BRETT AQUALINE TECHNICAL BULLETIN

BL-40 COMBO VALVE RELAY WIRING ERROR

April 30, 1999

BL-40 COMBO CORRECT VALVE WIRING DIAGRAM

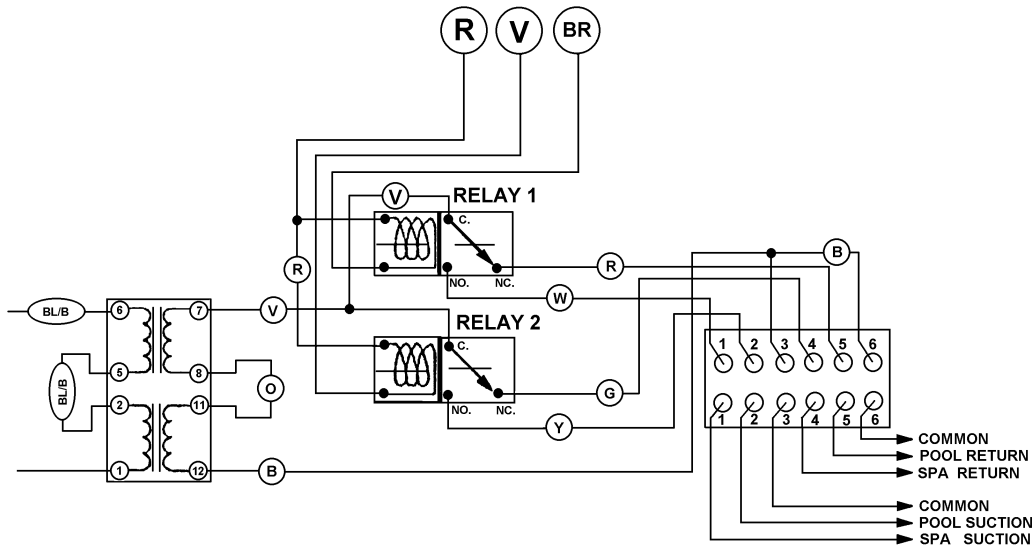
A small percentage of BL-40 Combo units may have a valve relay wiring error which may prevent the pool and spa valves from operating upon initial startup.

Should one of these units have valves that fail to operate properly upon startup, check the factory "pool suction" and "spa return" wiring. The correct wiring should be "POOL SUCTION" (yellow wire) connected to the valve relay's Normally Open (N.O.) terminal and the "SPA RETURN" (green wire) connected to the valve relay's Normally Closed (N.C.) terminal. The correct valve wiring is shown below.
